Well Name: WEST BISTI UNIT	Well Location: T26N / R13W / SEC 18 / SESW / 36.482697 / -108.261932	County or Parish/State: SAN JUAN / NM
Well Number: 104	Type of Well: OIL WELL	Allottee or Tribe Name:
Lease Number: NMNM013492	Unit or CA Name: WEST BISTI UNIT	Unit or CA Number: NMNM78448X
US Well Number: 300450581100S1	Operator: DUGAN PRODUCTION CORPORATION

Notice of Intent

Sundry ID: 2810371

Well: West Bisti Unit 104

Planned P & A Schematic

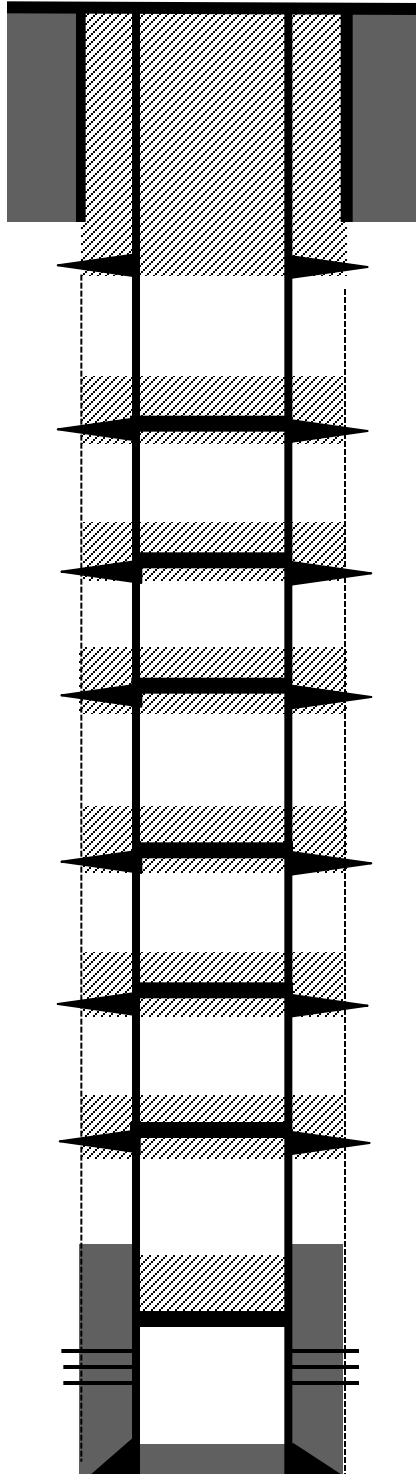
1. Plugging operations authorized are subject to the attached "General Requirements for Permanent Abandonment of Wells on Federal and Indian Lease."
2. The following modifications to your plugging program are to be made:
 - a. Modify the Plug 1 TOC to 5050' to account for the BLM geologist's pick for the Gallup.
 - b. Combine Plugs 7 & 8 to account for the BLM geologists picks for the Kirtland and Ojo Alamo tops: 420' for the Kirtland and unknown for the Ojo Alamo. Place the perforations at 470', the cement retainer at 420' and the TOC at the surface.
3. Farmington Office is to be notified at least 24 hours before the plugging operations commence at (505) 564-7750.

-Vertical wellbore, all formation depths are TVD from KB at the wellhead.
-BSC: Behind Surface Casing
-Modify the Plug 1 TOC to 5050' to account for the BLM geologist's pick for the Gallup.
-Combine Plugs 7 & 8 to account for the BLM geologists picks for the Kirtland and Ojo Alamo tops: 420' for the Kirtland and unknown for the Ojo Alamo. Place the perforations at 470', the cement retainer at 420' and the TOC at the surface.

Created By	Condition	Condition Date
mkuehling	Agree with BLM formation tops - CBL required from CIBP - fruitland top 980 run cement to 880 - Notify NMOCD 24 hours prior to moving on - monitor string pressures daily report on subsequent - submit all logs prior to subsequent	9/18/2024
